CPUC Docket: A.25-05-009
Exhibit Number: TURN-7-E2
Witness: Eric Borden

**PREPARED TESTIMONY OF
ERIC BORDEN**

**ADDRESSING WILDFIRE SYSTEM HARDENING AND CUSTOMER
BATTERY PROGRAM ISSUES IN PACIFIC GAS AND ELECTRIC'S
TEST YEAR 2027 GENERAL RATE CASE**

**February 13, 2026
Errata March 26, 2026
Second Errata April 24, 2026**

Figure 1. WDRMv2 UG Miles Completed from Highest to Lowest Risk

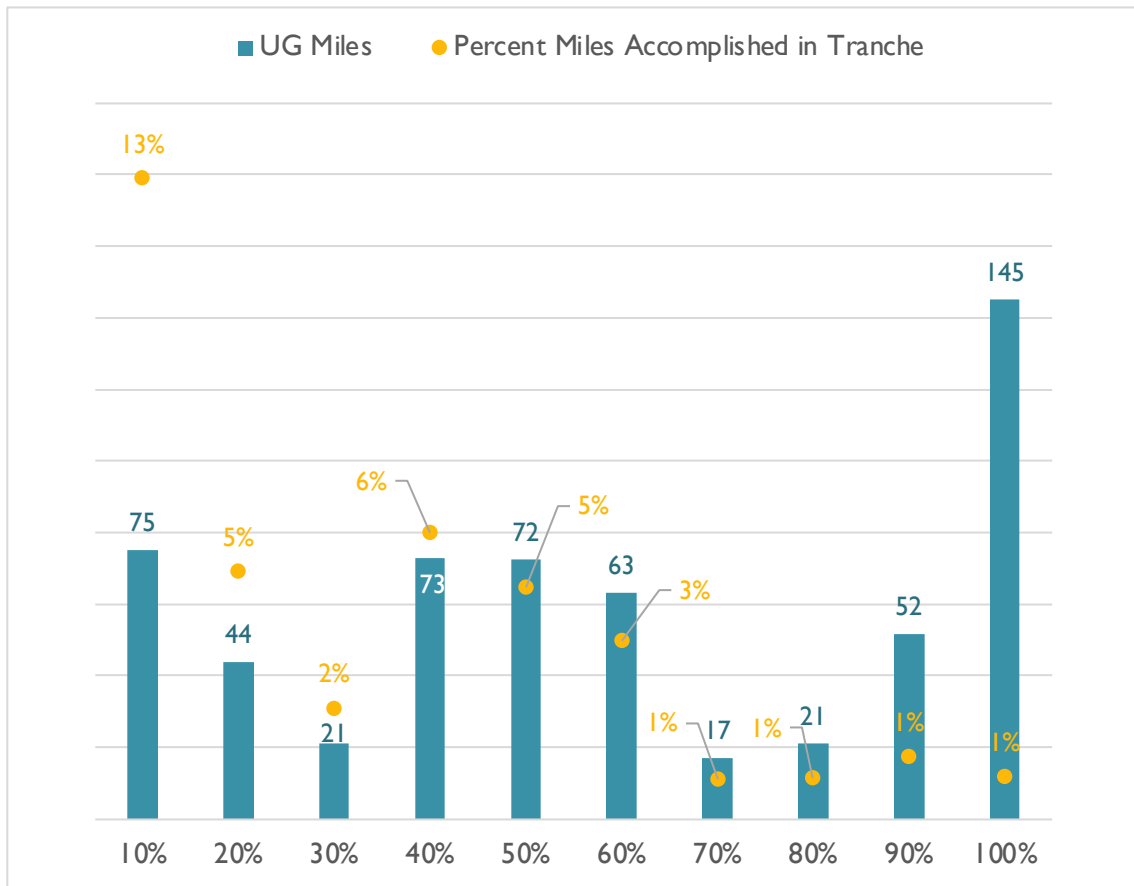
11 PG&E’s inability to target the highest risk miles according to its own risk models could be
12 because of limitations to how undergrounding projects are scoped, PG&E’s desire to meet
13 mileage targets rather than maximize risk reduction, or likely some combination of the two.
14 Either way, it reflects yet another severe limitation of PG&E’s undergrounding program. The
15 figure below shows miles completed using WDRMv2 to scope projects, with the far-left miles of
16 the figure showing the top 10 percent of risk according to this model, and the far right the bottom
17 10 percent of risk according to this model.

2 Of the 584 miles completed using WDRMv2 to scope projects, an astounding 64 percent were
 3 completed in the bottom 50 percent of risk; 25 percent in the bottom 10 percent! Further the
 4 figure shows that PG&E undergrounded only 13 percent of the miles (75) the in top 10 percent
 5 of risk, which consists of a total of 600 miles. In other words, a program that could be targeted to
 6 the highest risk assets could have accomplished the entire 584 miles in the top 10 percent of risk.

Figure 2. WDRMv2 UG Miles Completed from Highest to Lowest PG&E Risk Tranche

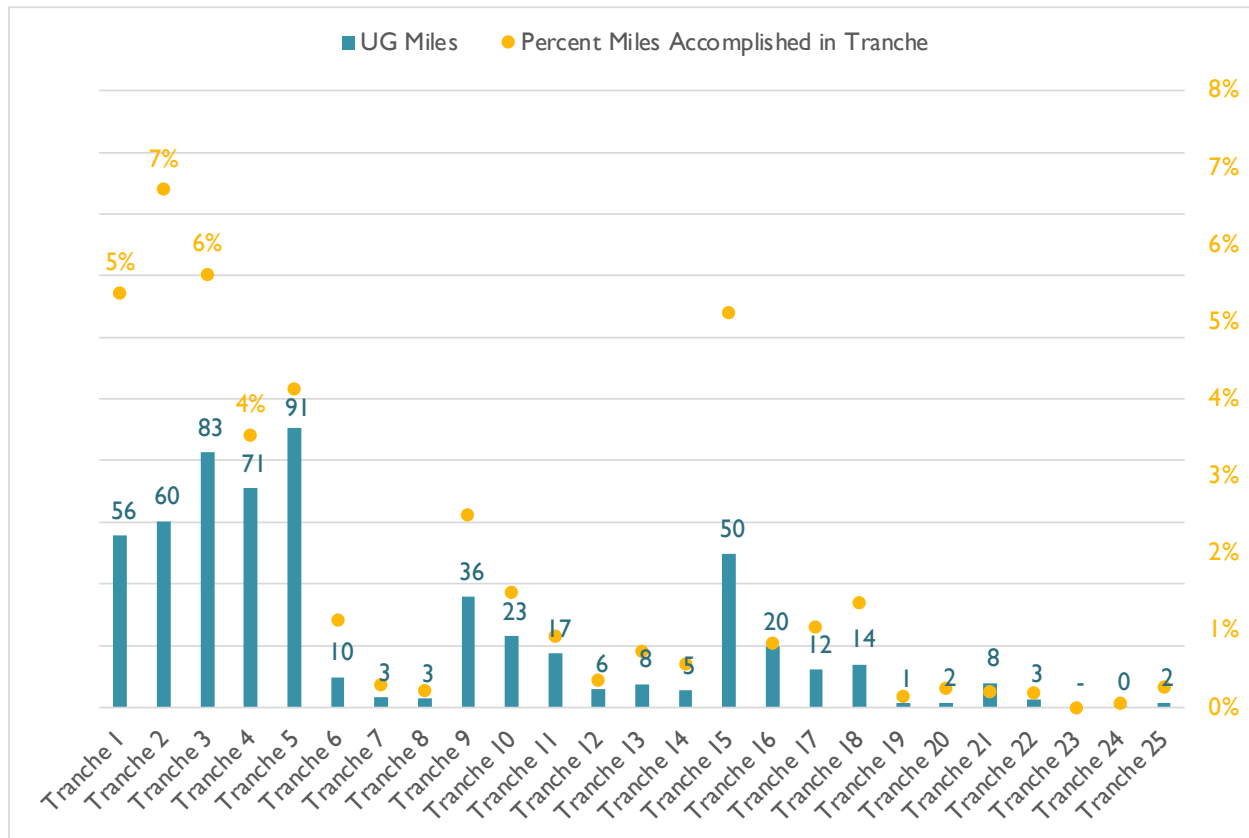
Next, the following figure shows these results by risk tranches as defined by PG&E, with tranche

1 **Figure 3. WDRMv3 UG Miles Completed from Highest to Lowest Risk**

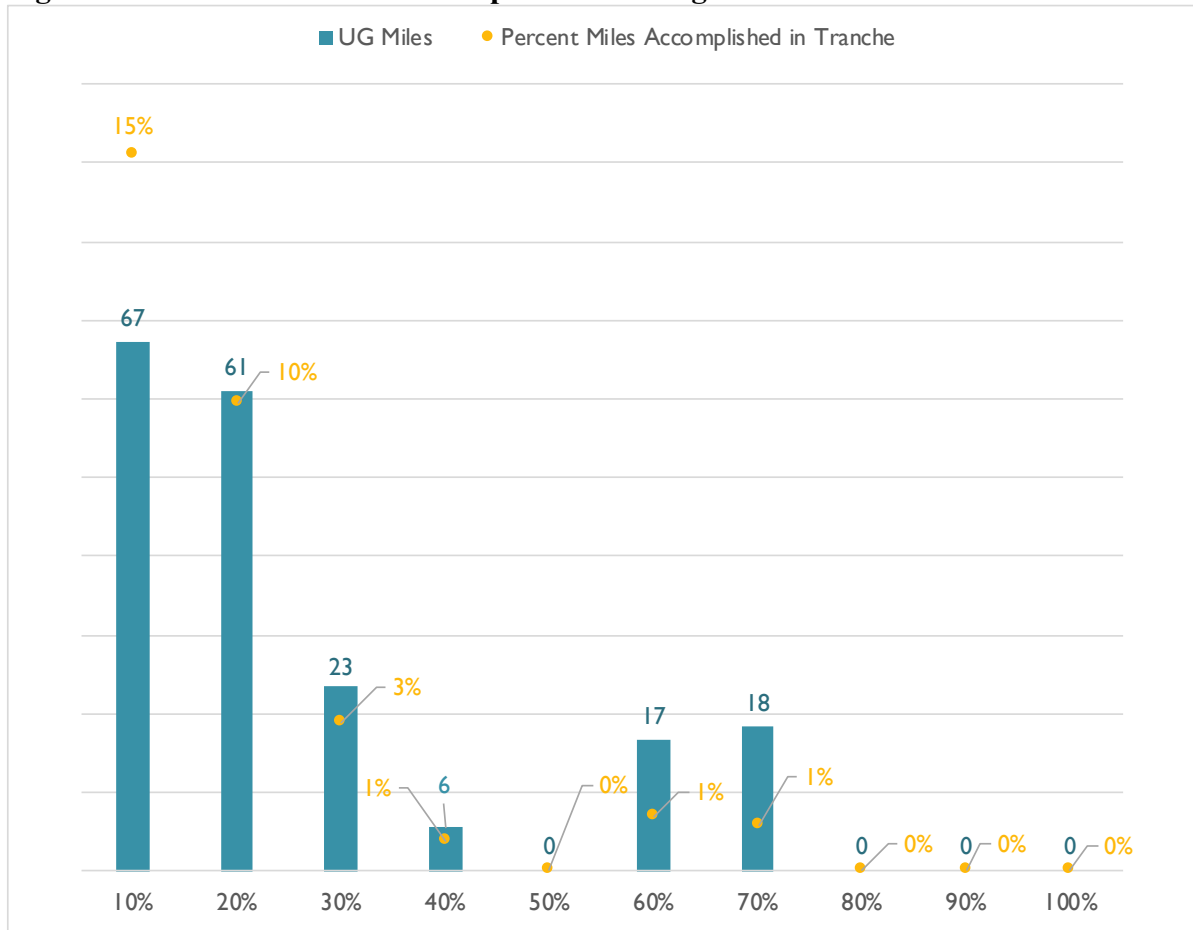
7 Slightly improved results can be seen below for the 192 underground miles that have utilized
 8 WDRMv3. Here again, however, a purely risk-based program could have deployed all 192 miles
 9 within the top 10 percent of risk (which has 435 miles in total), rather than just 35 percent.

1 **Figure 5. Undergrounding Miles by Risk Model Version (2023-2026)**

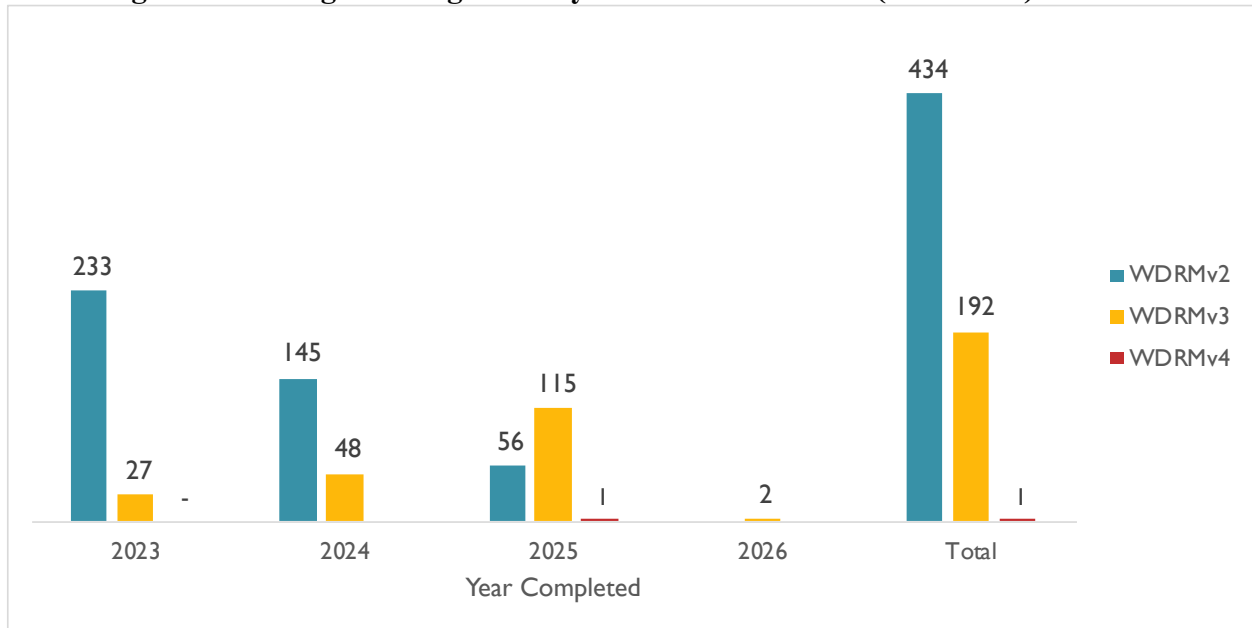
15 Another striking aspect of PG&E’s undergrounding performance is the degree to which projects
16 coming online in recent years rely on outdated risk modeling. This means that PG&E is unable to
17 rely on its latest assessments of risk for virtually any of the projects that it has undergrounded. Of
18 the 627 miles completed from 2023 to 2026, over two-thirds (69 percent) utilized just the second
19 version of PG&E’s risk model, due to the fact that undergrounding scoping, site preparation, and
20 other issues take so long.⁴¹

6 So while continual improvement in PG&E’s risk modeling approach has been a key focus of the
7 CPUC and OEIS, it has hardly yielded better project selection in terms of targeting what PG&E
8 believes are the highest risk locations for undergrounding projects. Indeed, for the 2027 forecast
9 in this GRC, 180 of the 307 miles would use previous risk models (v2 and v3),⁴² despite the fact
10 that the Commission is ostensibly deciding on expenditures for 2027.

5 **Figure 6. CBRs of PSPS and EPSS Mitigation Programs**

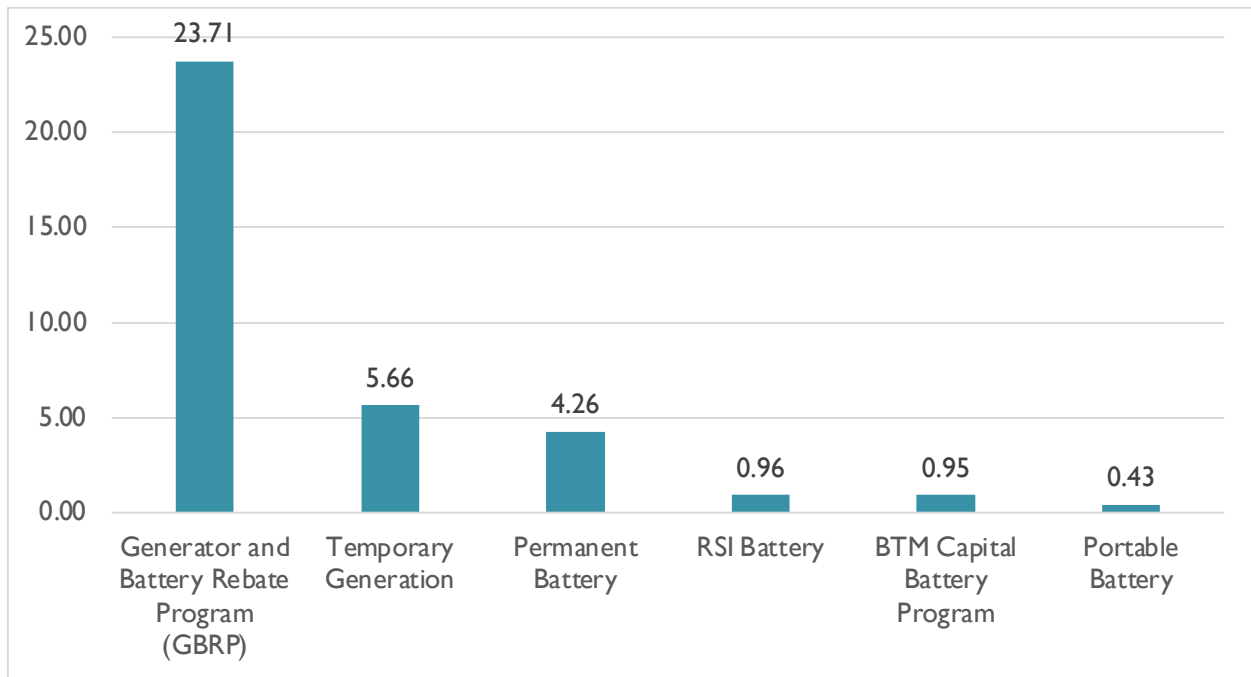
18 PG&E’s cost-effectiveness analysis demonstrates that the costs of battery programs which fully
19 subsidize customer costs are not cost-effective. As seen below, both the expense and capital
20 programs which fully subsidize batteries are expected to cost more than the value of lost load for

1 customers experiencing PSPS/EPSS events, as indicated by a cost-benefit ratio (CBR) less than
 2 one. On the other hand, by far the most cost-effective program conducted by PG&E, the GBRP,
 3 provides relatively small rebates (\$300 to \$500) for the installation of small generators. It may
 4 not be in the ratepayer interest to provide fully subsidized batteries to eligible customers.

1 **Figure 7. Number of Backup Power Units Deployed by Program, 2020-2024**

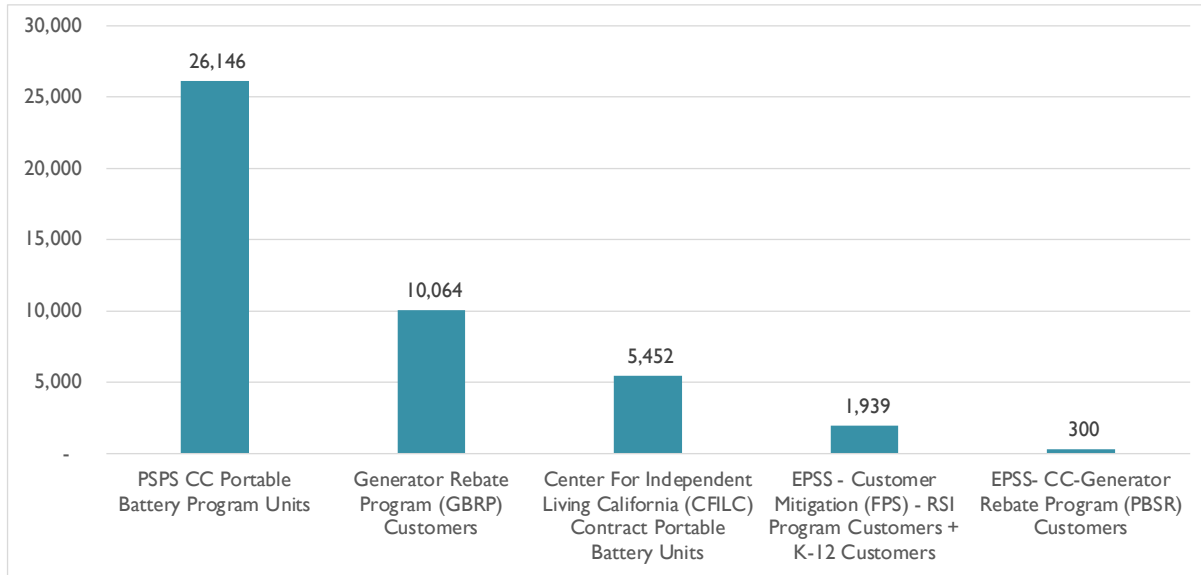
8 The GBRP has had the most success in deploying backup power to customers, likely with the use
 9 of small, inexpensive generators that run just a few hours a year if an outage occurs.⁵⁸
